Re: Cantata at the Trails, DRB 1002962 (C-09/D001B)

This letter is an addendum to the approved drainage report for Cantata at the Trails, dated 8/22/07. The purpose of this addendum is to remove Sump Inlet 8 (and corresponding storm drain), at the intersection of Streets #4 and #10, as shown on the attached drainage basin map. This inlet is being removed because Street 10 has capacity to carry the 14.92 cfs at Sump Inlet 8, plus the 4.51 cfs from Basin 3A1, to Sump Inlet 12 at the intersection of Streets #2 and #10. In addition, Inlet 12 has the capacity to pass 21.2 cfs (14.92 cfs from Inlet 8 and 6.3 cfs from Inlet 12).

This letter provides additional information to the original addendum, dated 4/30/12, for the approved Cantata at the Trails drainage report, dated 8/22/07. The purpose of the original addendum was to show that the removal of Sump Inlet 8 (and corresponding storm drain), at the intersection of Streets #4 and #10, as shown on the drainage basin map from the 8/22/07 drainage report, was valid. The analysis provided looked at the fully developed condition and showed that the inlet was not needed. The conclusions of the original addendum are still valid. This letter

## BASIN MAP FOR SUBDIVISION AND BUILDING PERMIT **CANTATA AT THE TRAILS**

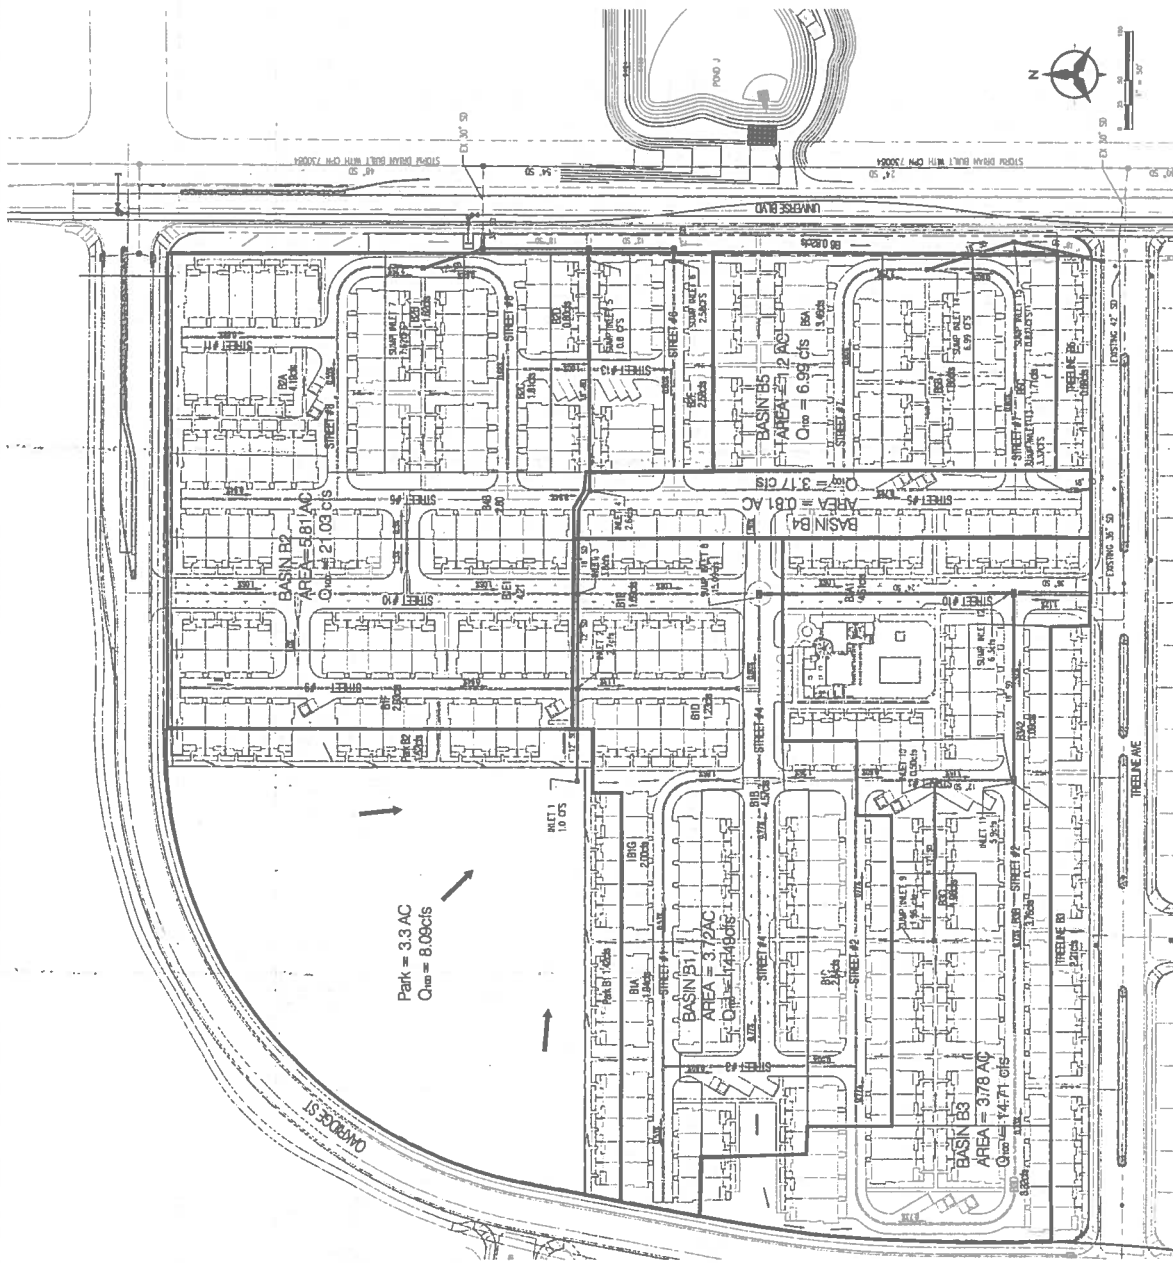
The carrying capacity of Street #10 is limited by the 20' wide street section at the southeast corner of the Pool/Clubhouse area. This section has a capacity of approximately 25 cfs, which is greater than the combined flow at Sump Inlet 8 and from Basin 3A1. See the attached street capacity calculation.

This addendum shows that Street 10 can safely convey flows to Sump Inlet 12 and that Sump Inlet 12 has the capacity to accept these additional flows. Therefore, Sump Inlet 8 and the 24-inch storm drain between inlets 12 and 8 are not required for the site to drain.

## BASIN MAP FOR SUBDIVISION AND BUILDING PERMIT **CANTATA AT THE TRAILS**

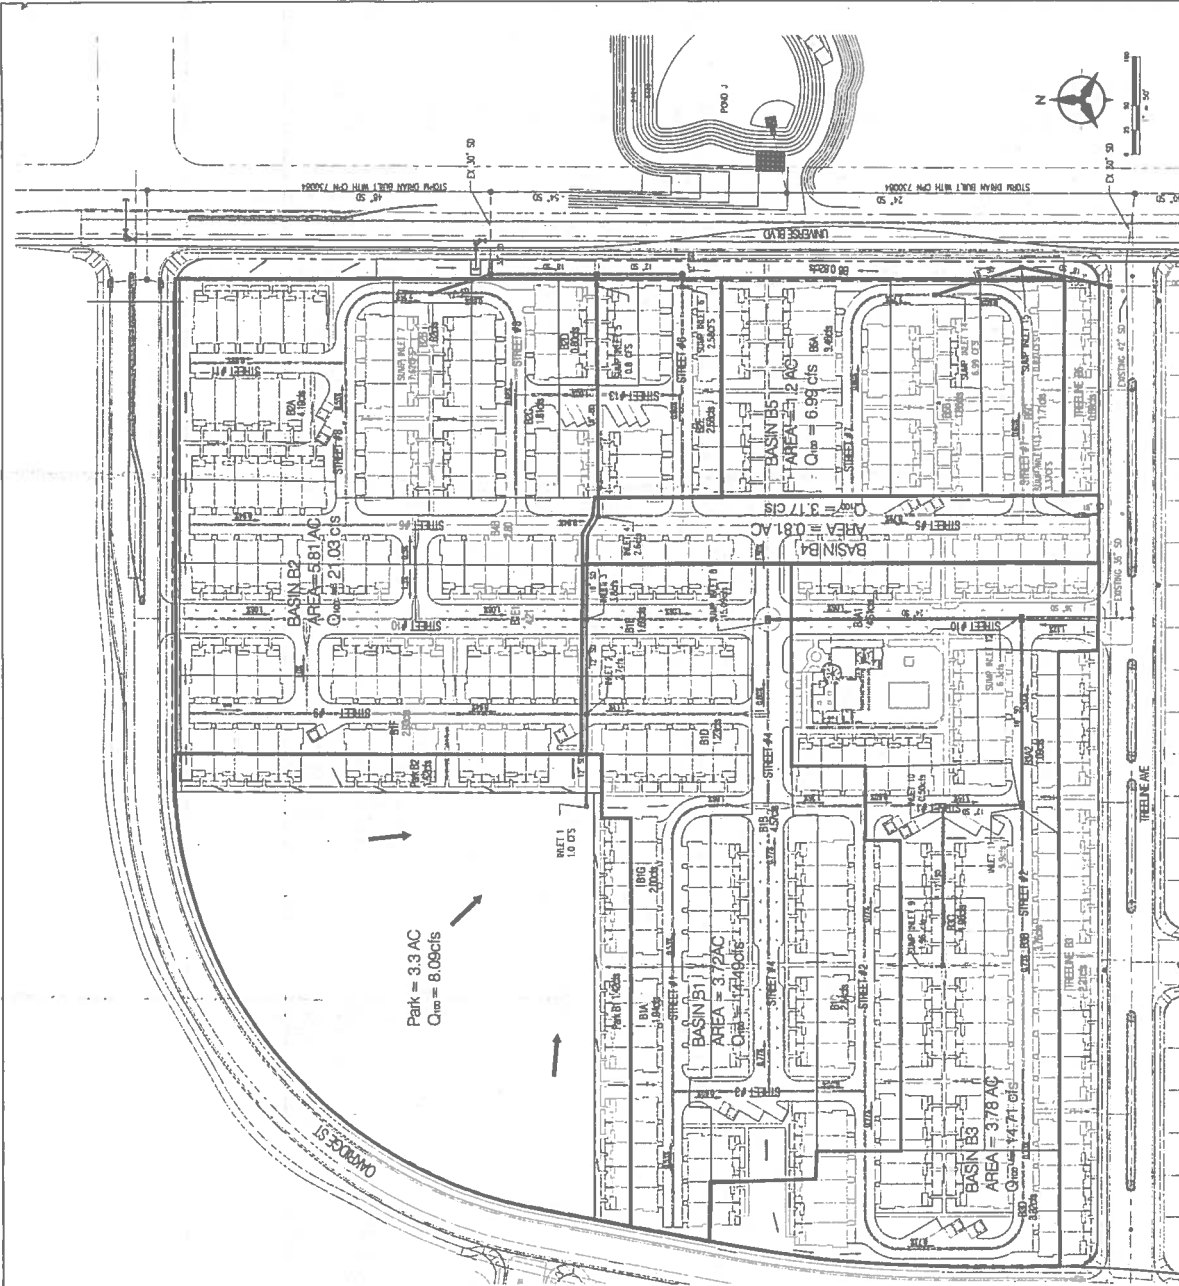
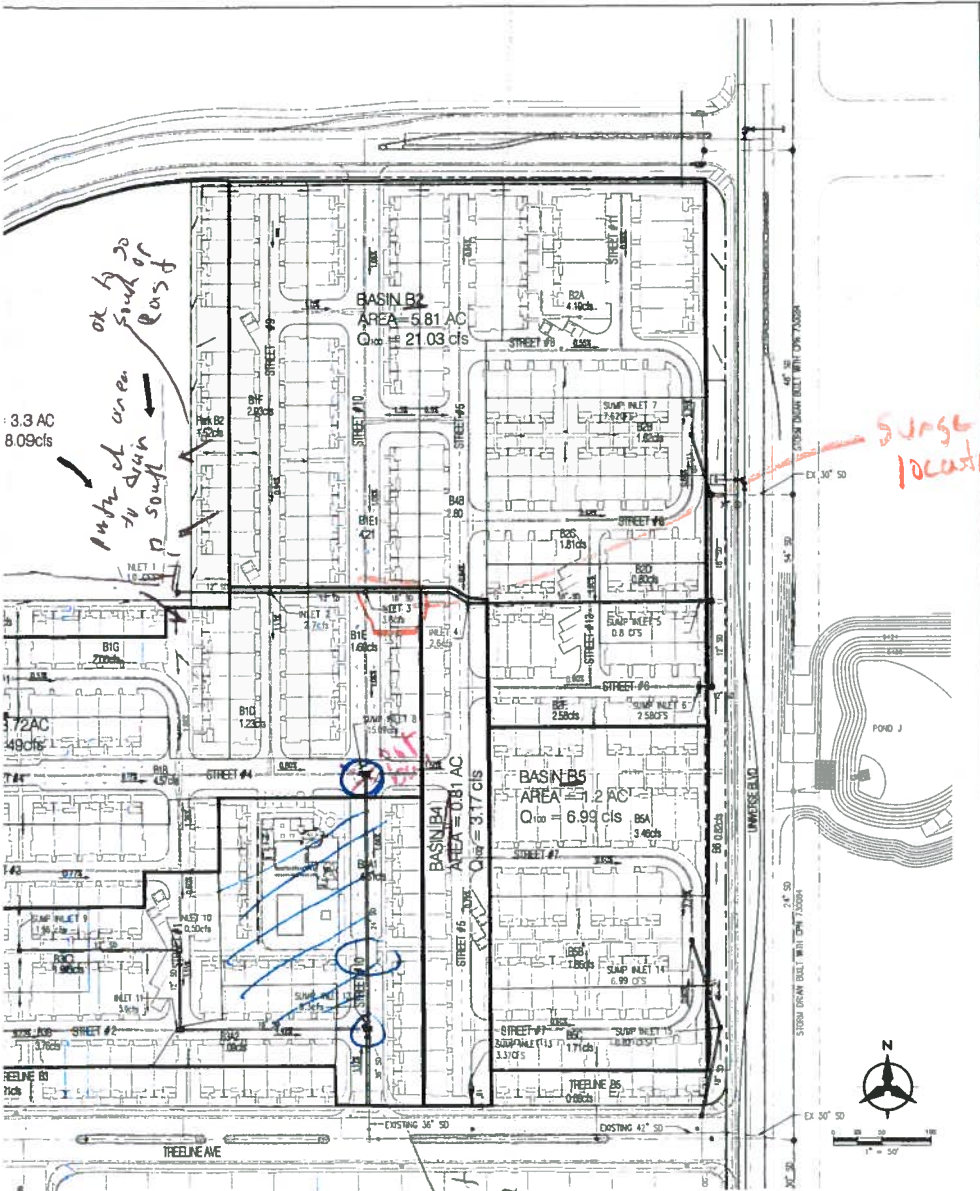
There is additional flow getting to Street 10 and Sump Inlet 12 from Basins B1F and B1E1 in the interim condition because the inlets at the south end of these basins have not been constructed at this time. The flow reaching the intersection of Streets #4 and #10 in the interim condition is 19.6 cfs. Street 10 has capacity to carry the 19.6 cfs at the intersection of Streets #4 and #10, plus the 4.5 cfs from Basin 3A1, to Sump Inlet 12 at the intersection of Streets #2 and #10. In addition, Inlet 12 has the capacity to pass 25.9 cfs (19.6 cfs from Inlet 8 and 6.3 cfs from Inlet 12) in the interim condition.

The carrying capacity of Street #10 is limited by the 20' wide street section at the southeast corner of the Pool/Clubhouse area. This section has a capacity of approximately 28 cfs, which is greater than the combined flow (24.1 cfs) at the intersection of Streets #4 and #10 and from Basin 3A1 in the interim condition. See the attached street capacity calculation.

In addition, we looked at the "park" area (Cantata Tract A) in the interim condition. Tract A was supposed to be a park that detained flow and discharged to the Cantata Tract B storm drain at 1 cfs in the approved Cantata drainage report. Since that time the zoning for Tract A has changed to allow for apartments to be developed on the 3.2 acre tract. Currently, Tract A is lower than Tract B based on a topographic survey provided by SurvTek dated 5/15/12, creating a pond that holds runoff in the interim condition. The volume of the "pond" is 2.4 acre-feet which is 8 times the 100-year, 24-hour runoff volume of 0.3 acre-feet from Basins Park B1, Park B2 and Park in the interim condition.

## BASIN MAP FOR SUBDIVISION AND BUILDING PERMIT

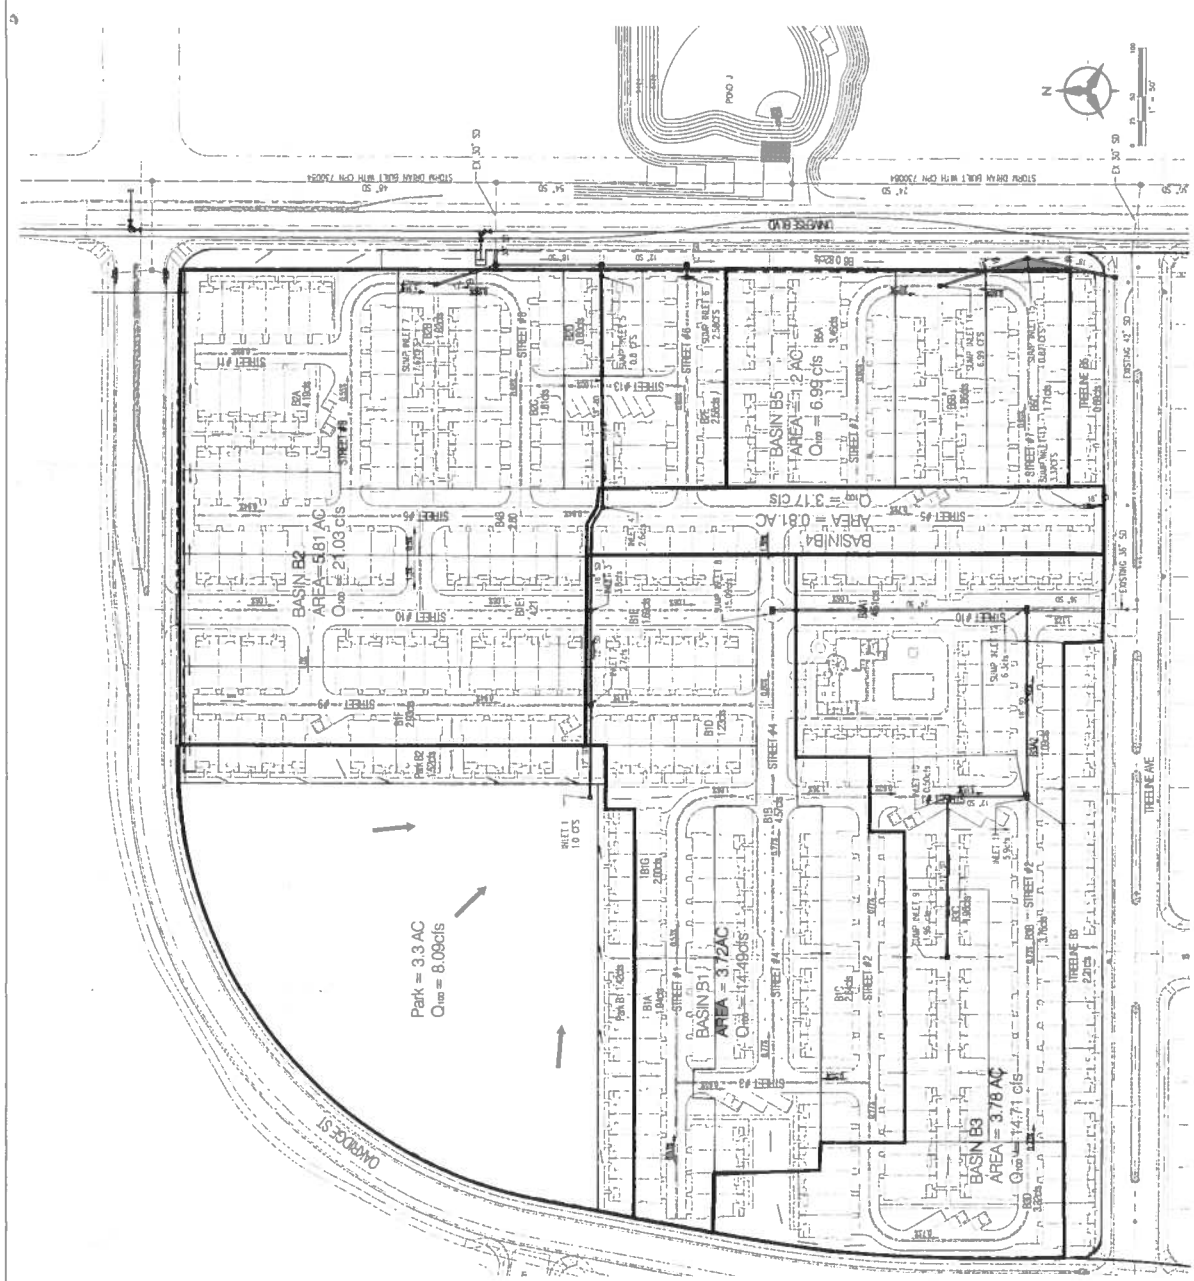
- The sump inlet summary does not contain all of the contributing basins. Since the inlets in Street 9 and 10 north of the clubhouse have not been built, basins B1F and B1E1 drain to sump inlet # 12. In addition, the summary does not include the "park" area.
- The next submittal should include Basins B1F and B1E1 as land treatment "C" and include the "park" area.

There is additional flow getting to Street 10 and Sump Inlet 12 from Basins B1F and B1E1 in the interim condition because the inlets at the south end of these basins have not been constructed at this time. The flow reaching the intersection of Streets #4 and #10 in the interim condition is 19.6 cfs. Street 10 has capacity to carry the 19.6 cfs at the intersection of Streets #4 and #10, plus the 4.5 cfs from Basin 3A1, to Sump Inlet 12 at the intersection of Streets #2 and #10. In addition, Inlet 12 has the capacity to pass 25.9 cfs (19.6 cfs from Inlet 8 and 6.3 cfs from Inlet 12) in the interim condition.

The carrying capacity of Street #10 is limited by the 20' wide street section at the southeast corner of the Pool/Clubhouse area. This section has a capacity of approximately 28 cfs, which is greater than the combined flow (24.1 cfs) at the intersection of Streets #4 and #10 and from Basin 3A1 in the interim condition. See the attached street capacity calculation.

In addition, we looked at the "park" area (Cantata Tract A) in the interim condition. Tract A was supposed to be a park that detained flow and discharged to the Cantata Tract B storm drain at 1 cfs in the approved Cantata drainage report. Since that time the zoning for Tract A has changed to allow for apartments to be developed on the 3.2 acre tract. Currently, Tract A is lower than Tract B based on a topographic survey provided by SurvTek dated 5/15/12, creating a pond that holds runoff in the interim condition. The volume of the "pond" is 2.4 acre-feet which is 8 times the 100-year, 24-hour runoff volume of 0.3 acre-feet from Basins Park B1, Park B2 and Park in the interim condition.
